SYDNEY WEST CENTRAL PLANNING PANEL

Panel Reference	2016SYW179
DA Number	318/2017/JP
LGA	THE HILLS SHIRE COUNCIL
Proposed Development	CONSTRUCTION OF A RESIDENTIAL FLAT BUILDING DEVELOPMENT CONTAINING 150 UNITS AND BASEMENT PARKING
Street Address	PROPOSED LOT 41 IN APPROVED PLAN OF PROPOSED SUBDIVISION OF LOT 1 DP 523737 AND LOT A DP 380729, NOS. 227-241 HEZLETT ROAD, KELLYVILLE
Applicant/Owner	APPLICANT: BRAD DELAPIERRE OWNERS: MR J P PUPO, MR P PUPO, MR M A PUPO, MS G M PUPO AND MRS F PUPO
Date of DA lodgement	26 AUGUST 2016
Number of Submissions	ONE
Recommendation	APPROVAL SUBJECT TO CONDITIONS
Regional Development Criteria (Schedule 4A of the EP&A Act)	CIV EXCEEDING \$20 MILLION
List of all relevant s79C(1)(a) matters	<ul style="list-style-type: none"> • SEPP (SYDNEY REGION GROWTH CENTRES) 2006 • SEPP (STATE AND REGIONAL DEVELOPMENT) 2011 • SEPP NO. 55 — REMEDIATION OF LAND • SEPP NO. 65 — DESIGN QUALITY OF RESIDENTIAL APARTMENT DEVELOPMENT • NORTH KELLYVILLE DCP 2008 • DCP 2012 PART C SECTION 1 – PARKING • DCP 2012 PART C SECTION 3 – LANDSCAPING

EXECUTIVE SUMMARY

ATTACHMENT 11 – PROPOSED VARIATIONS TO SETBACKS

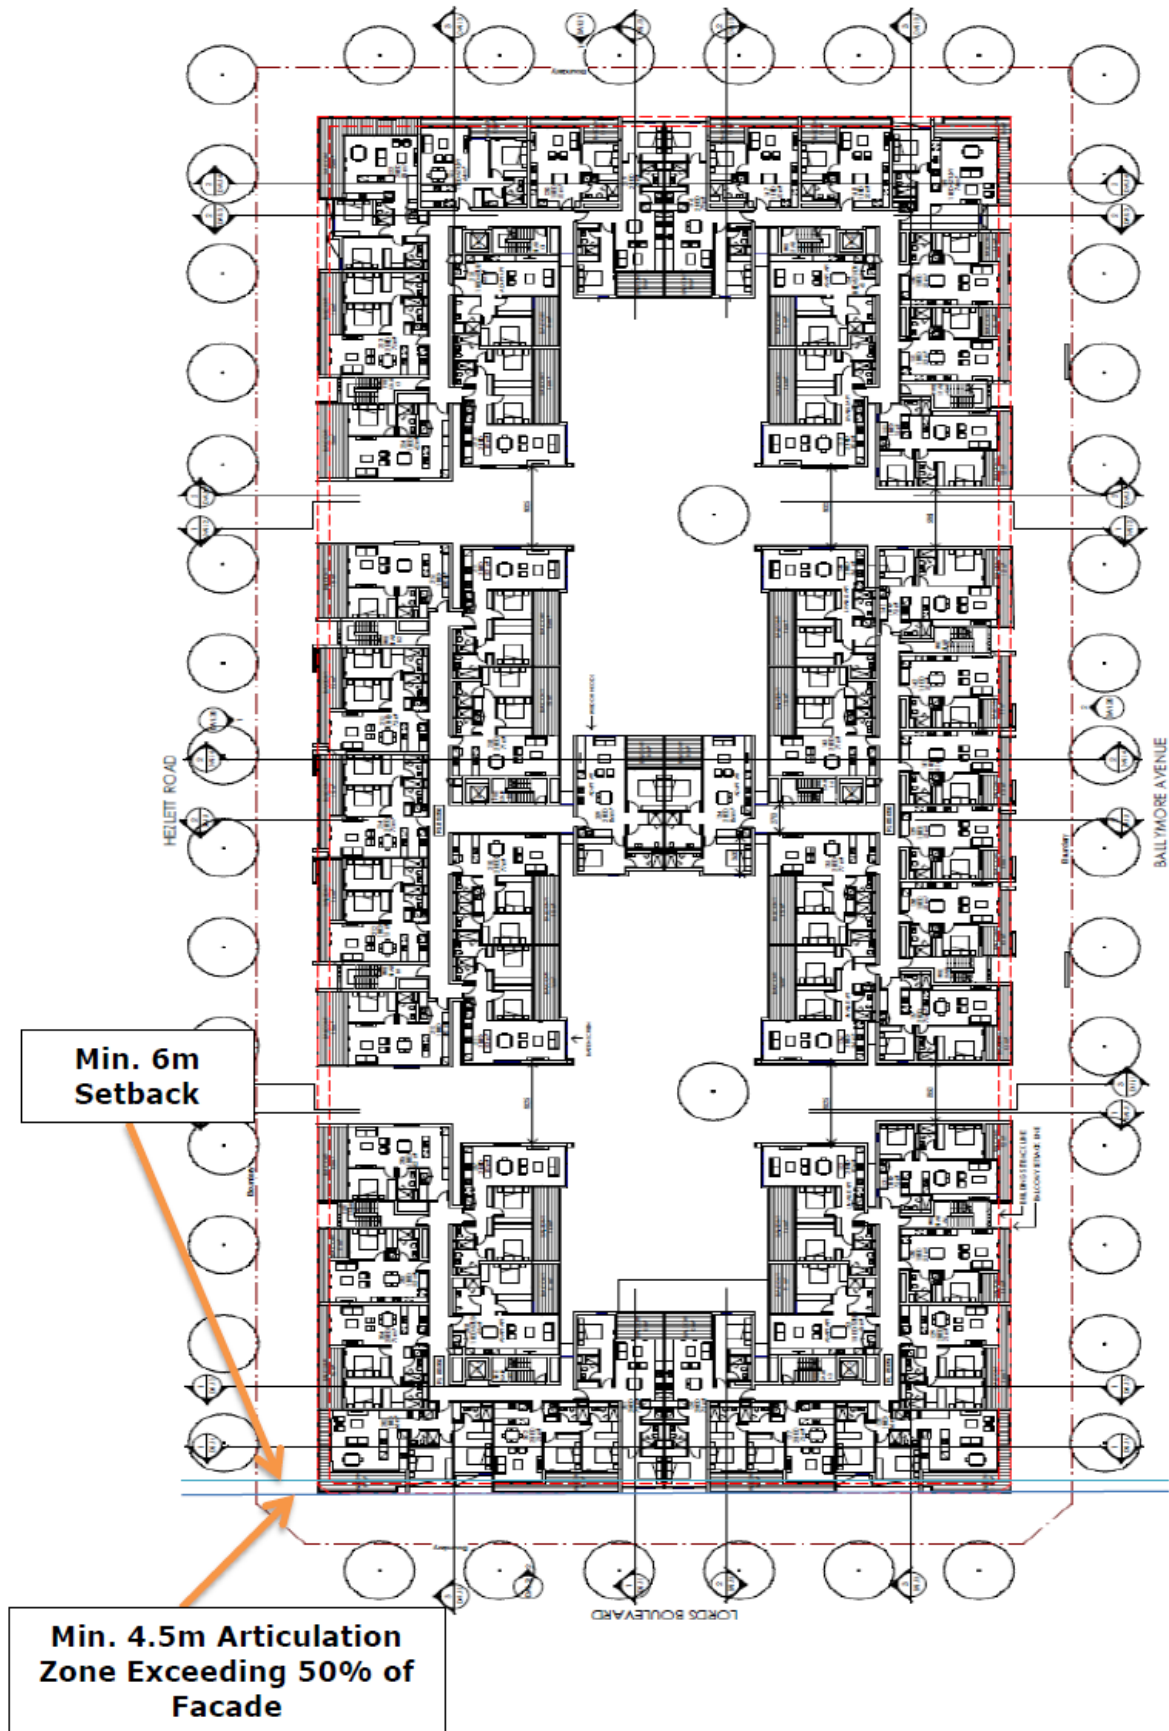
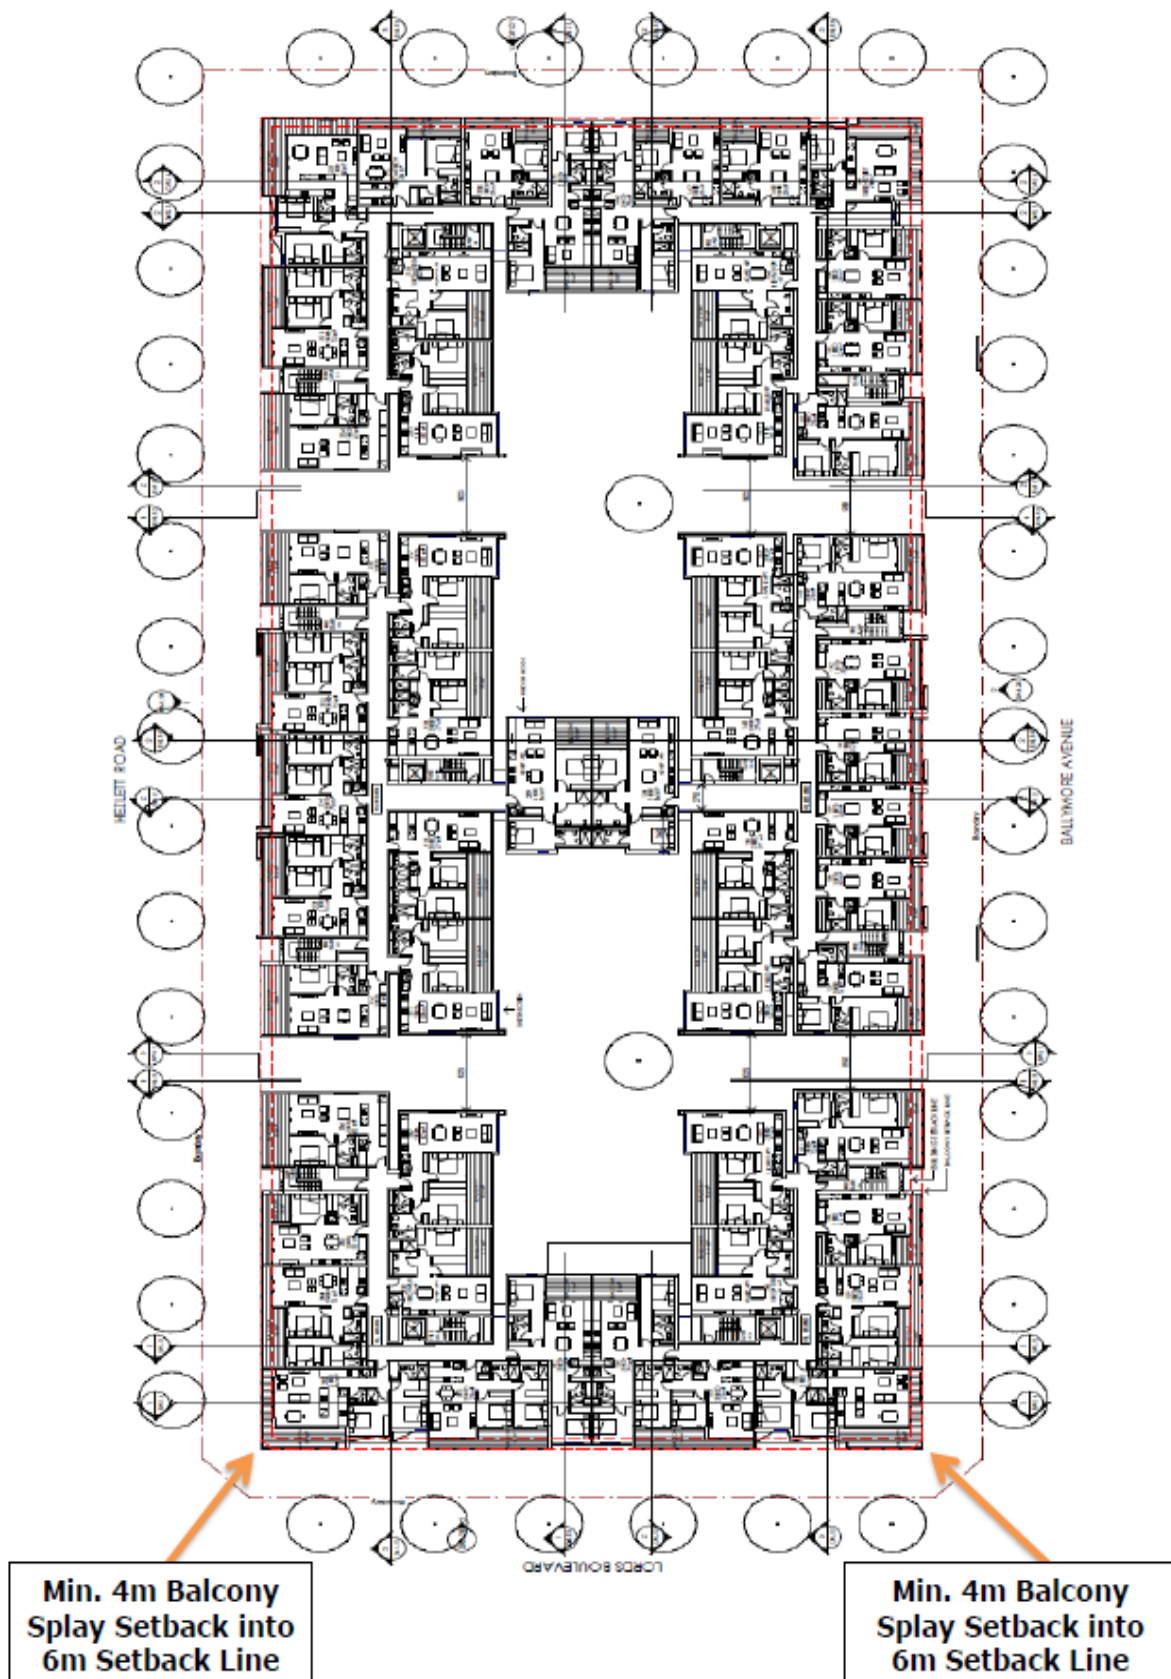
The development includes encroachments into the minimum 6m front, secondary and side building setback requirements of the North Kellyville DCP. A minimum 4.5m articulation setback is permitted for the front setback to Ballymore Avenue for up to 50% of the façade. A minimum 4.5m front setback is proposed for 54% of the front facade. There are minimum 4m balcony setbacks to the splay corners and 4.5m balcony setbacks to the secondary/side boundaries. In conjunction with the landscaping, a reasonable streetscape is provided and the impacts of the built form are minimised. There will be no unreasonable loss of privacy or amenity as a result of the variations. The design of the development provides articulation and is considered worthy of support in this instance.

The balcony encroachments are appropriate to activate the street noting that the proposal achieves the site coverage and landscape requirements. The balconies provide articulation and a degree of visual interest to the building.

The variations do not result in any significant adverse impacts on adjoining properties and they add to the articulation of the building façade. The setbacks have been designed to ensure that there is an appropriate landscape setting for the development with satisfactory landscaping works proposed within the setback areas. There will be no adverse visual impacts as deep soil plantings are provided for around the perimeter of the development. The proposed setbacks are satisfactory and can be supported.

ATTACHMENT 12 – PROPOSED VARIATIONS TO SEPARATION

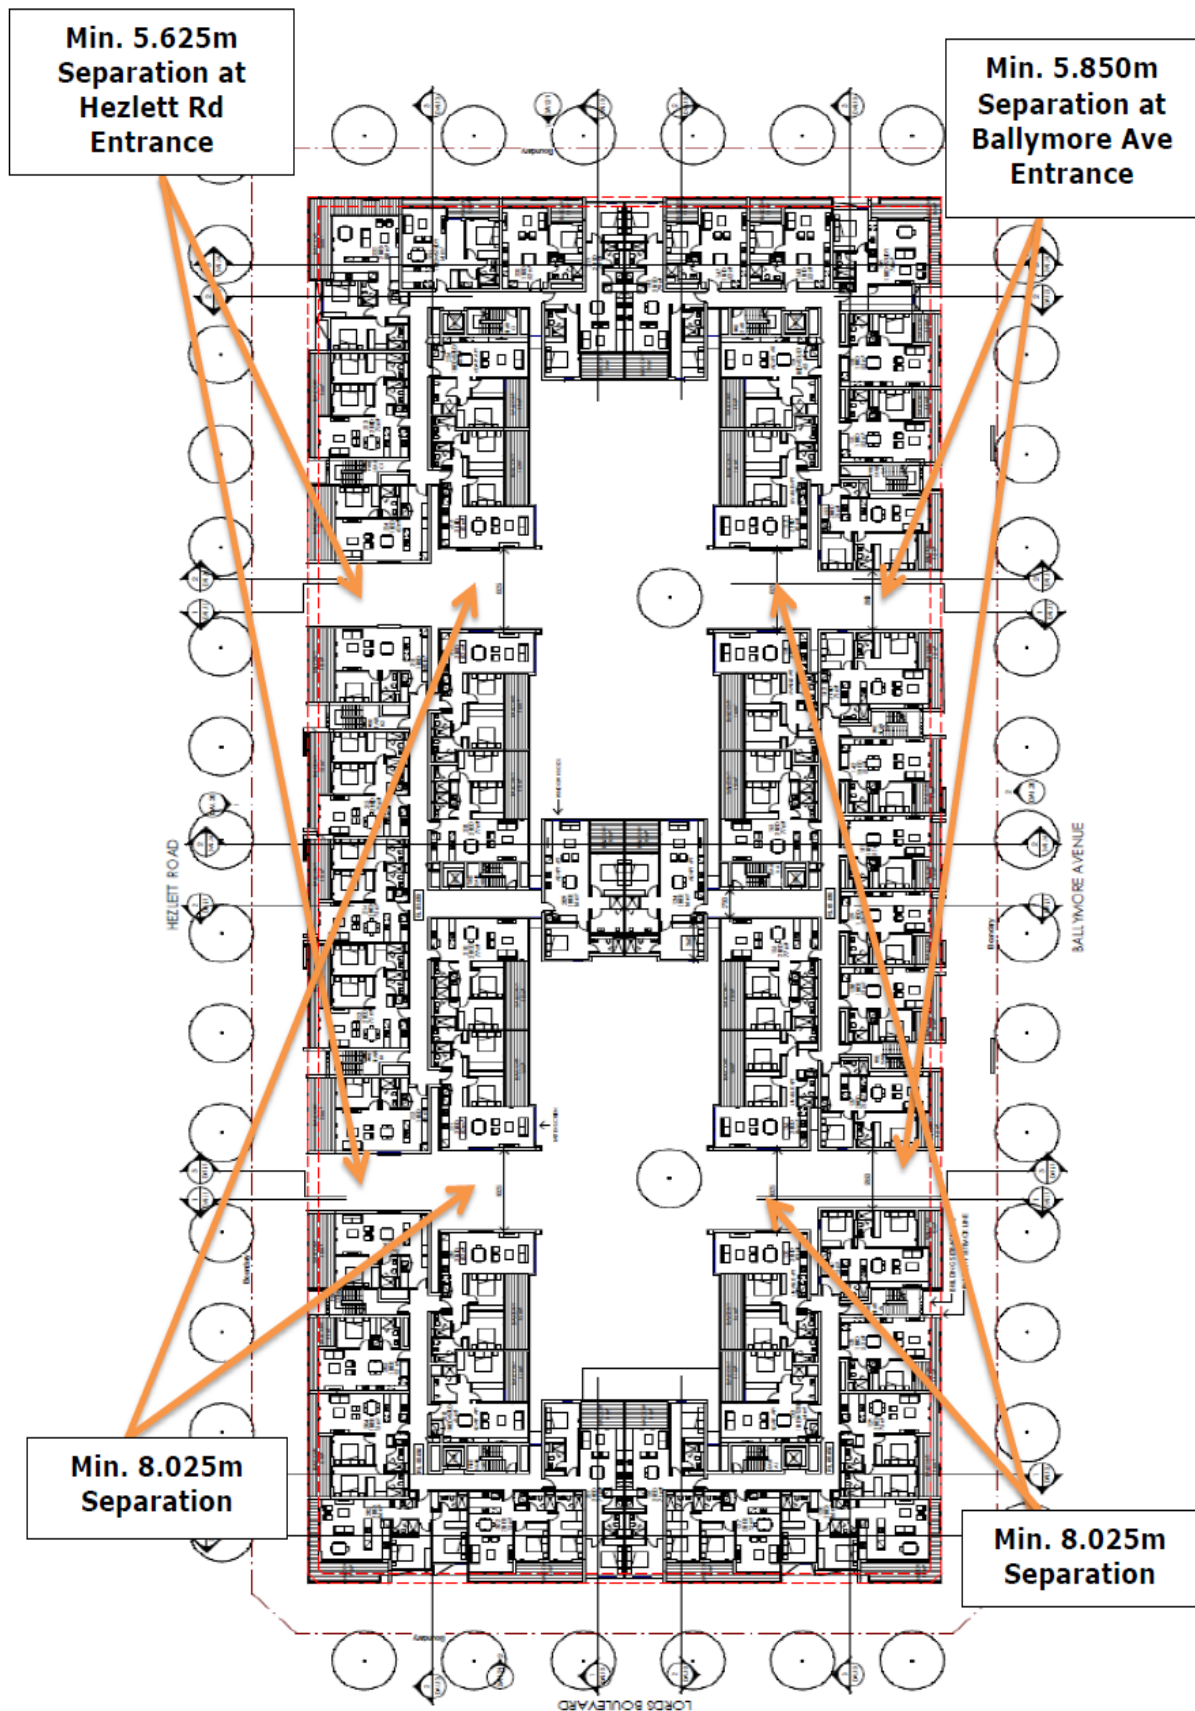
The development also includes encroachments into the minimum 12m building separation requirement to include a minimum 5.6m building separation. The proposed variation is supported as a satisfactory privacy outcome is achieved.

The proposed building separation is due to the shape and design of the development. The extent of the separation varies considerably and the areas of non-compliance mainly occur at the Ballymore Avenue and Hezlett Road entrances. The 5.6m separation involves living room windows facing each other which contains high level windows and other reduced setbacks provide detailing for blank walls and offset windows. An appropriate built form articulation is provided for without unreasonably impacting on the privacy/amenity levels of future residents. The building is appropriately massed in accordance with the desired scale of the precinct. The proposal satisfies the above aims and is supported in this instance.

ATTACHMENT 15 – SHADOW DIAGRAMS

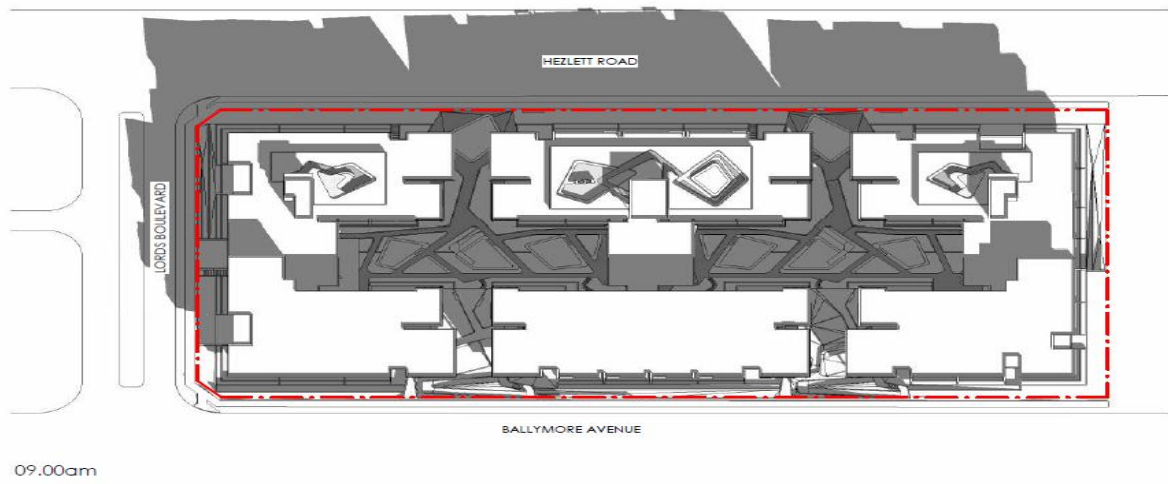
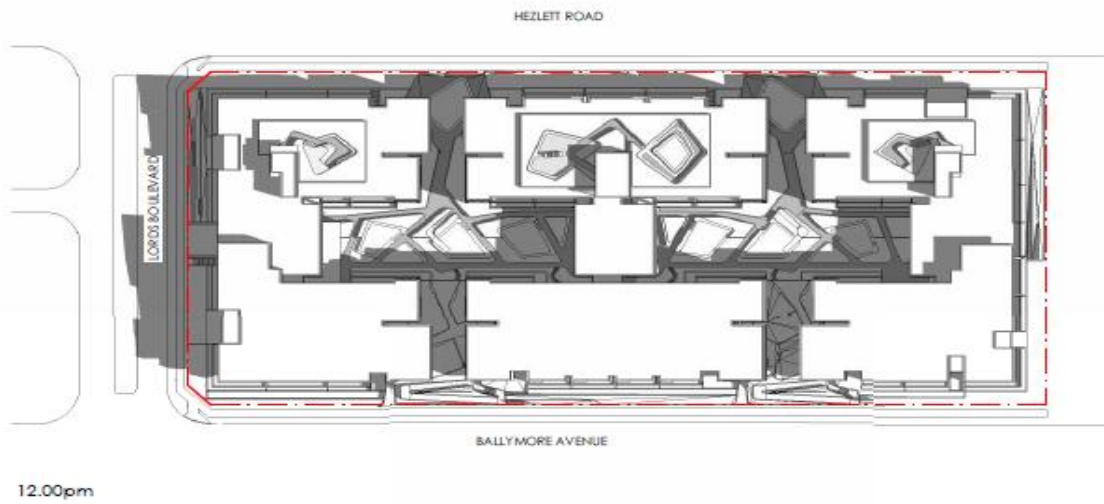
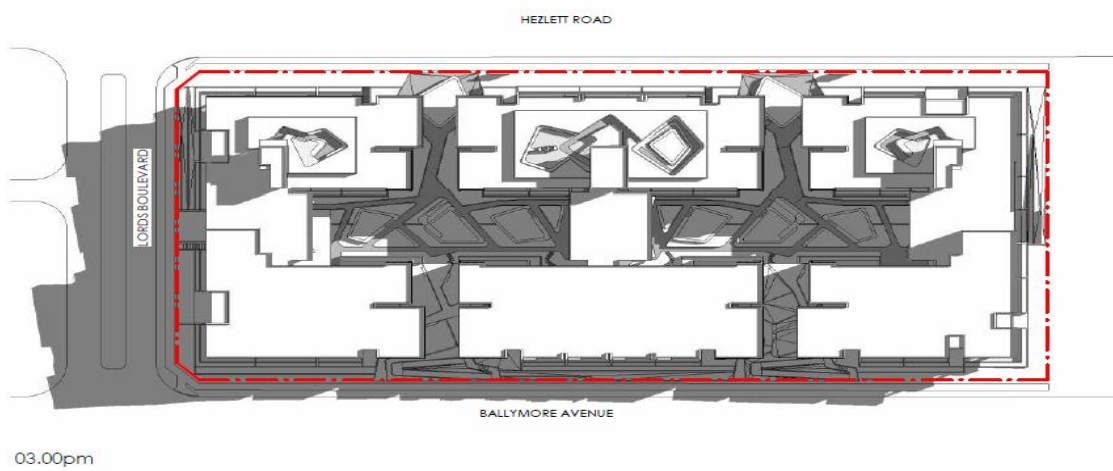
The total common open space areas provided on the site at 38.6% exceed the minimum 15% required under the North Kellyville DCP. The increased height will have no impact upon the solar access on surrounding lots or the amenity of the area. The proposal attempts to respond to the slope of the site within its context and the applicant has provided a revised scheme by deleting units to reduce the bulk of the development.

The height of the development is satisfactory as it is appropriately separated from any adjoining development and the shadow impact does not adversely impact on the amenity of adjoining developments. This separation will reduce the potential for overlooking and any adverse privacy impacts. The height variation is due to the slope of the land which is primarily related to the three lift cores, stairwells and hallways that provide access to the roof top common open space areas. This design arrangement provides for an improved planning outcome as opposed to providing a fully complying development in relation to building height. The total common open space areas provided on the subject site at 38.6% exceeds the minimum 15% required under the North Kellyville DCP. The proposal attempts to respond to the existing topography of the site within its context and the applicant has provided a revised scheme by deleting upper level units to reduce the bulk of the development.
